SECOND FLOOR PLAN - NOZZLE

CHARLES D. KEFFER, II - CONSULTING ENGINEER Roanoke, Virginia	
RENOVATION & ALTERATIONS TO COULTER BLDG. & NATL. BUSINESS COL. JEFFERSON ST. AT FRANKLIN RD., ROANOKE, VA.	DATE 22 MAY 87
MARTIN BROS. CONTRACTORS, INC. ROANOKE, VIRGINIA	SHEET M-2A

DUCTWORK-HVAC

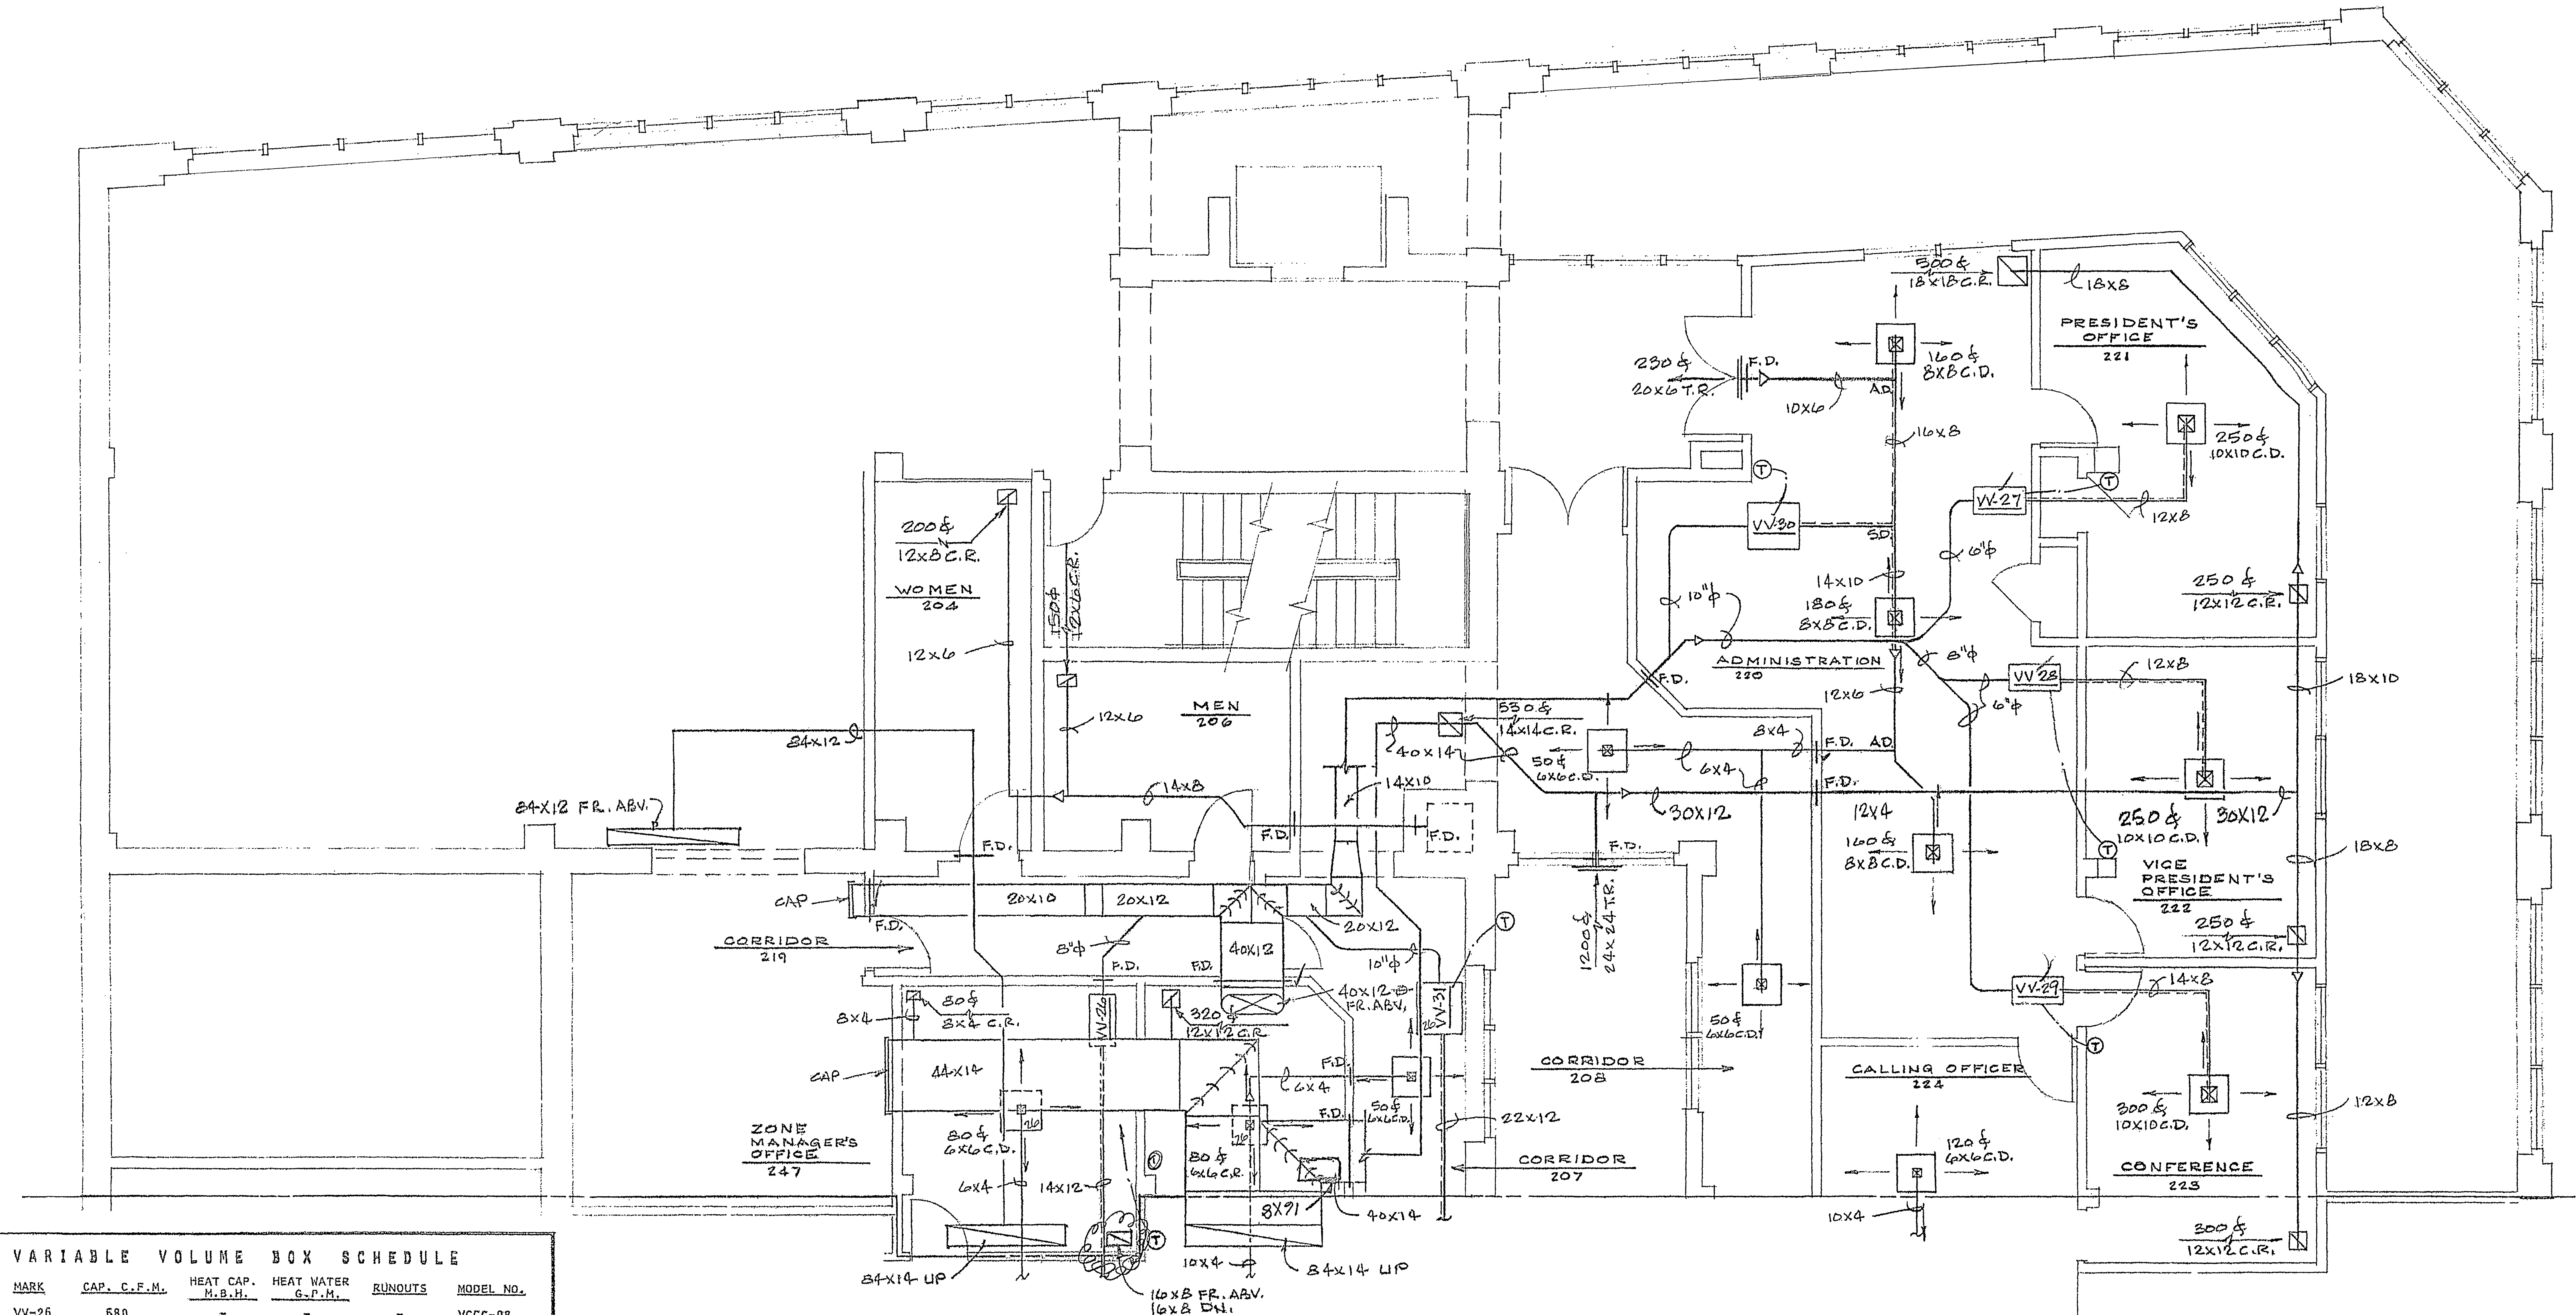
#26 OK T-stat Needs to be relocated
